**From:** Tavarez, Ike <Ike.Tavarez@tetratech.com>  
**Sent:** Thursday, October 17, 2013 1:31 PM  
**To:** Bratcher, Mike, EMNRD  
**Cc:** Robert McNeill; Robert Grubbs; Michelle Mullins (MMullins@concho.com)  
**Subject:** COG Operating - Weens #1 Tank Battery - Work Plan Approval Request  
**Attachments:** COG-Work Plan - WEEMS\_#1.pdf

**Re: Work Plan for the COG Operating LLC., Weems #1 Tank Battery, Unit B, Section 34, Township 22 South, Range 27 East, Eddy County, New Mexico.**

Reference: COG Production, LLC \* Weems 1 \* 30-015-35789 \* B-34-22s-27e \* Eddy County, New Mexico  
NMOCD Tracking number: 2RP-1725 \* Date of release: 7/9/2013

Figure 4

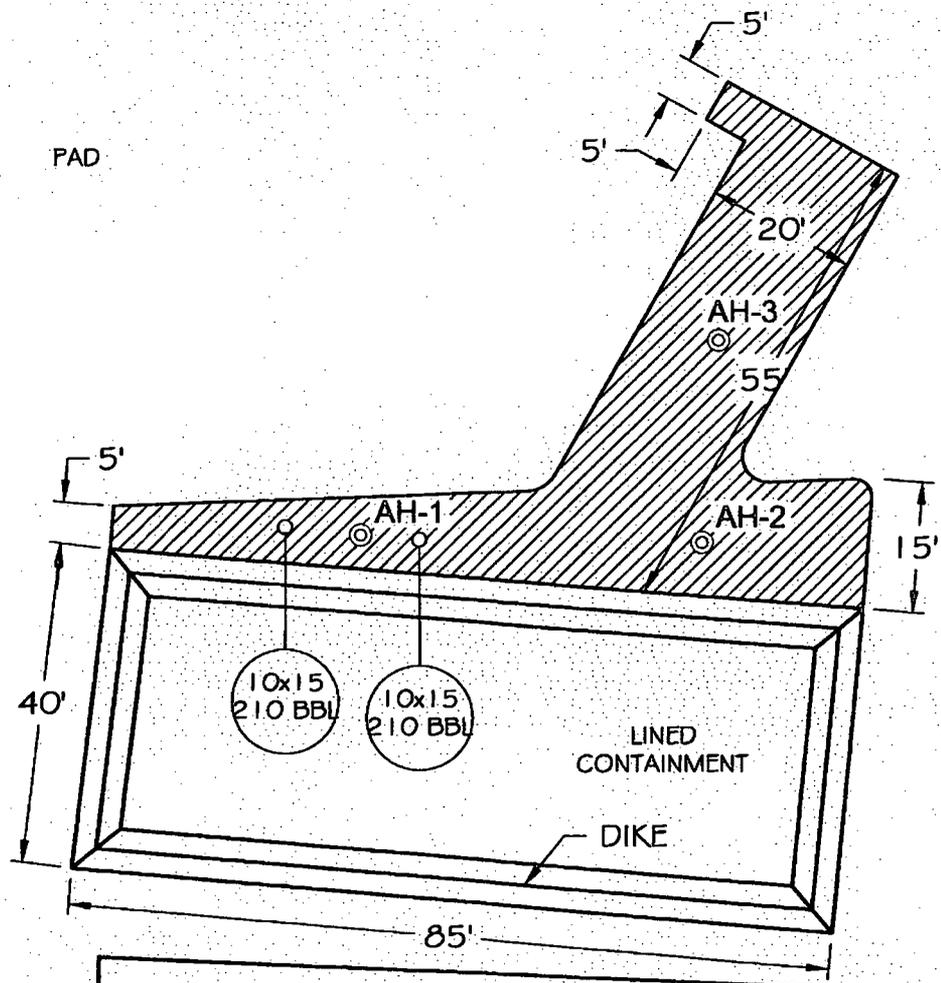
Your proposal for remediation of the above referenced release is approved. Please provide results obtained from the delineation trenches prior to backfilling, and, advise in the event the proposed excavation depths are not achieved. It was noted in the proposal that initially, the released fluids were in a lined battery, but no fluids were recovered. Please advise as to the condition of the liner at this facility.
